## ORIGINATION FORM

### Proposed Revisions to a Standard Plans Index

Index Number: 550-010  
Sheet Number (s): 2 of 4  
Index Title: BRIDGE FENCING (VERTICAL)

INDEX SHEET  
550-010 2 of 4

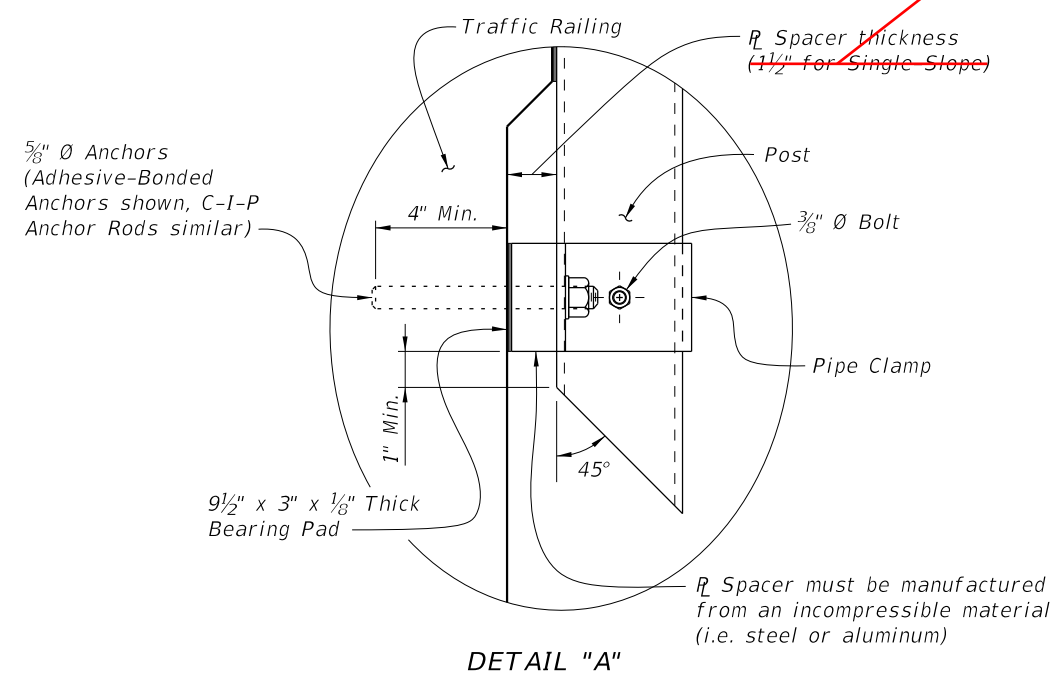
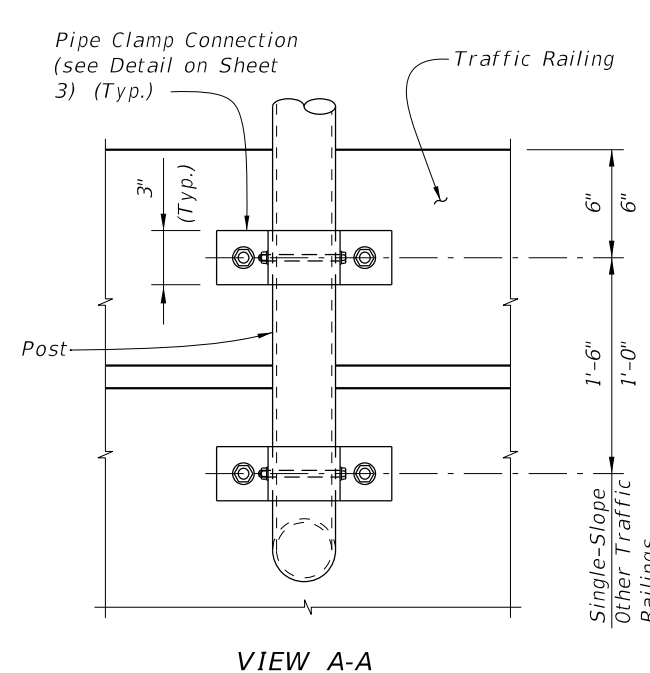
Sheet 2: Changed the shim thickness at the base of the pole to indicate that it varies based on railing type.

Contractor comments indicated their was some confusion ordering correct shims based on the existing language.

(thickness varies based on railing type)
